STAFF RECOMMENDATION
1903 Russell Street
May 20, 2020

Application: New Construction—Infill
District: Lockeland Springs-East End Neighborhood Conservation Zoning Overlay
Council District: 06
Base Zoning: R6
Map and Parcel Number: 08314009800
Applicant: Cheyenne Smith
Project Lead: Jenny Warren jenny.warren@nashville.gov

<p>Description of Project: Construct infill house to replace house demolished after the March 3, 2020 tornado.</p> <p>Recommendation Summary: Staff recommends approval of the project with the following conditions:</p> <ol style="list-style-type: none"> 1. The finished floor height be consistent with the finished floor heights of the adjacent historic houses, to be verified by MHZC staff in the field; 2. The front setback shall roughly match that of the house at 1905 Russell, to be verified by MHZC staff in the field; 3. Staff approve the final materials including: roofing color, stone, doors, windows and walkway materials, prior to purchase and installation; 4. A front walkway shall be added from the house to the sidewalk, and 5. The HVAC be located behind the house or on either side, beyond the mid-point of the house. <p>With these conditions, staff finds that the

Figure 5. Right side elevation

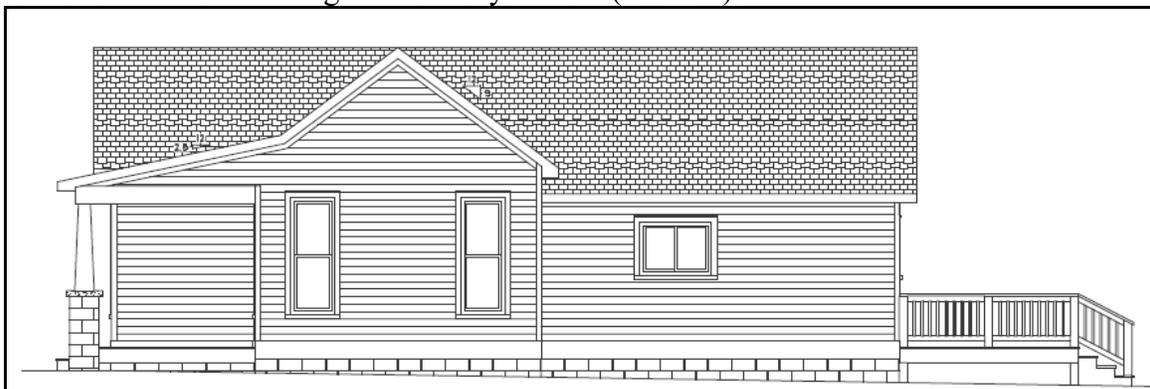
The proposed house will be about forty-six feet (46') deep and will have a total footprint of about one-thousand-five-hundred square feet (1,500sqft). There will be an uncovered deck at the rear measuring about ten by sixteen (10'x16').

Staff finds that the infill’s height and scale meet Sections II.B.1 and 2. of the design guidelines.

EXTERIOR
 ELEVATIONS

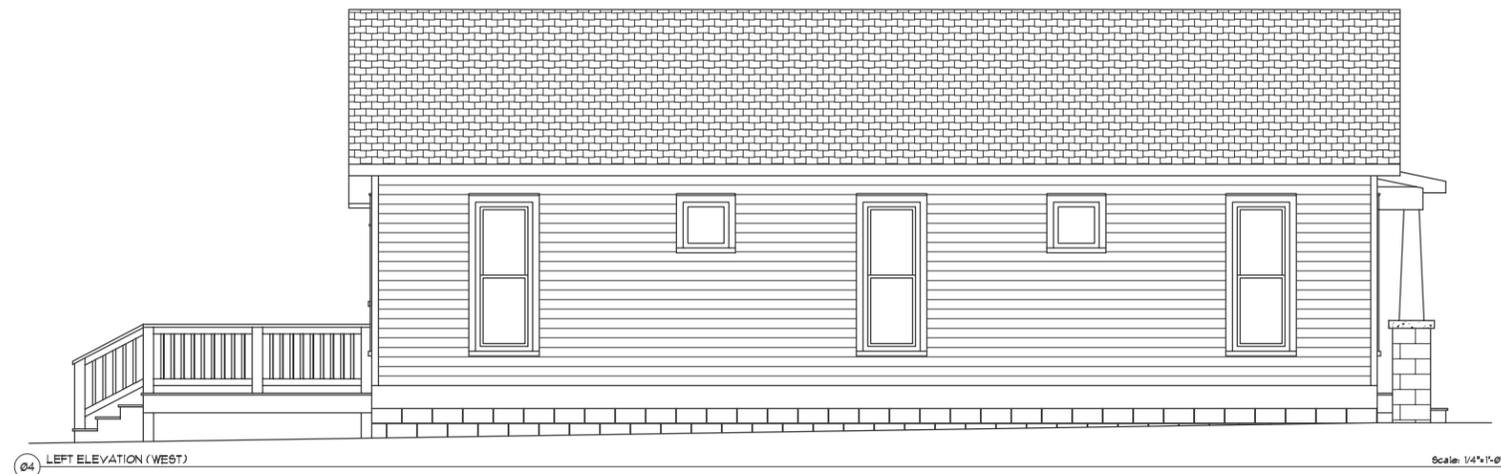
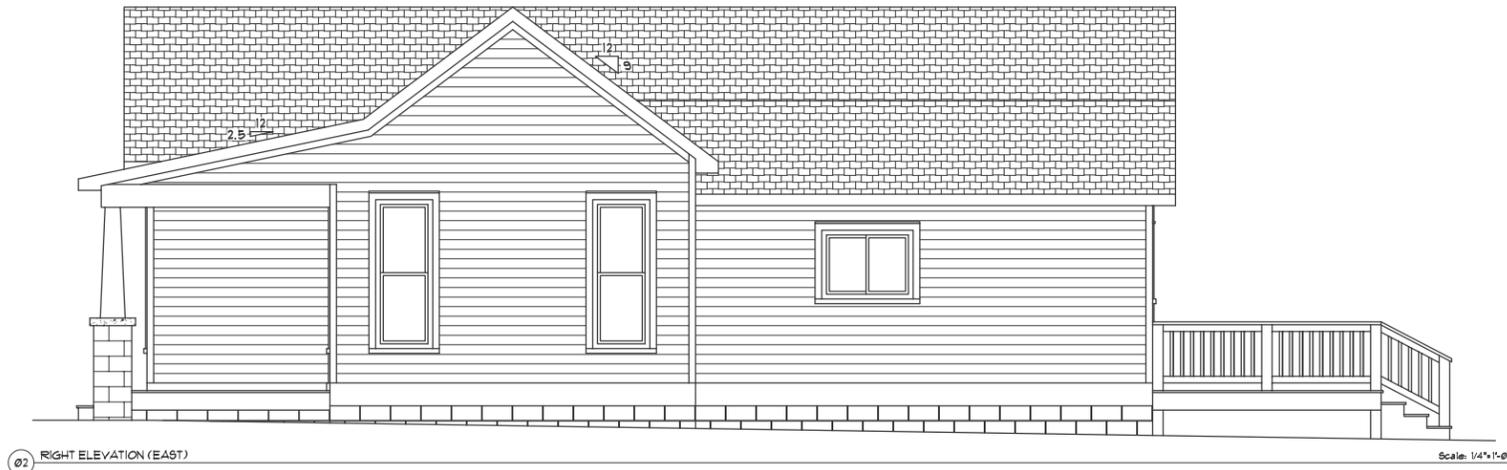
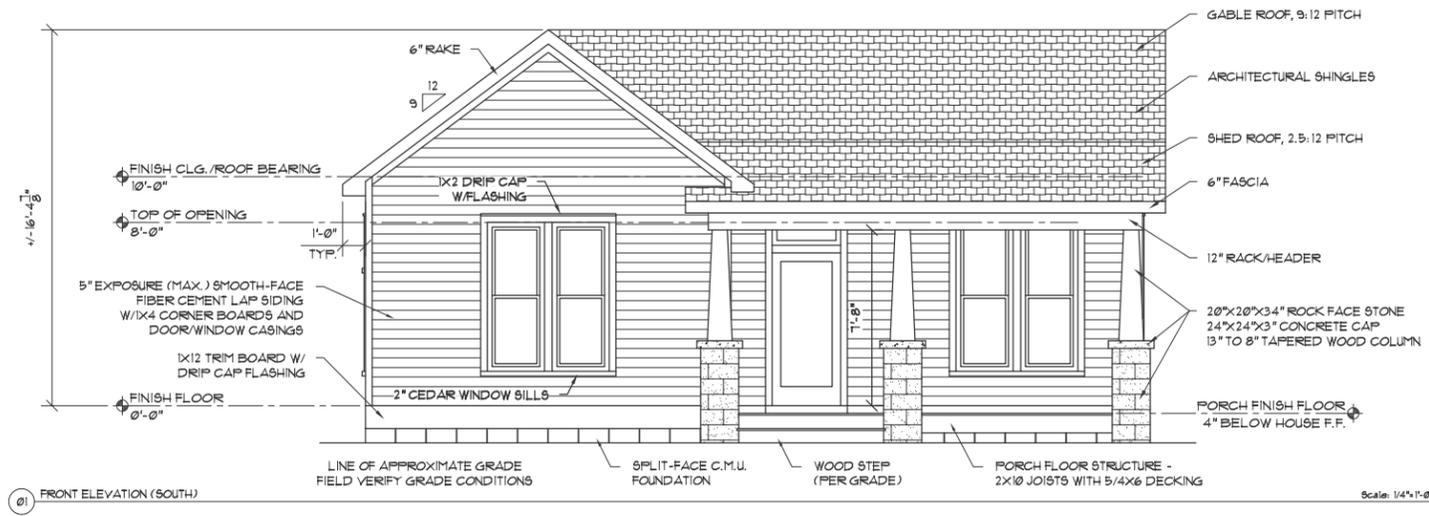
The house uses a front-gabled and side gabled roof form with a 9/12 slope. The porch and rear wing also have a shed roof with a 2.5/12 slope. These roof forms are typical of the neighborhood.

Proportion and Rhythm of Openings: The windows on the proposed infill are all generally twice as tall as they are wide, thereby meeting the historic proportions of openings. The exceptions are a few small square windows. Staff finds that these could be appropriate because they are used sparingly on the side elevations and are primarily located beyond the midpoint of the house. There are no large expanses of wall space without a window or door opening.

Appurtenances & Utilities: The location of the HVAC and other utilities was not noted. Staff asks that the HVAC be located on the rear façade, or on a side façade beyond the midpoint of the house.

1. The finished floor height be consistent with the finished floor heights of the adjacent historic houses, to be verified by MHZC staff in the field;
2. The front setback shall roughly match that of the house at 1905 Russell, to be verified by MHZC staff in the field;
3. Staff approve the final materials including: roofing color, stone, doors, windows and walkway materials, prior to purchase and installation;
4. A front walkway shall be added from the house to the sidewalk, and
5. The HVAC be located behind the house or on either side, beyond the mid-point of the house.
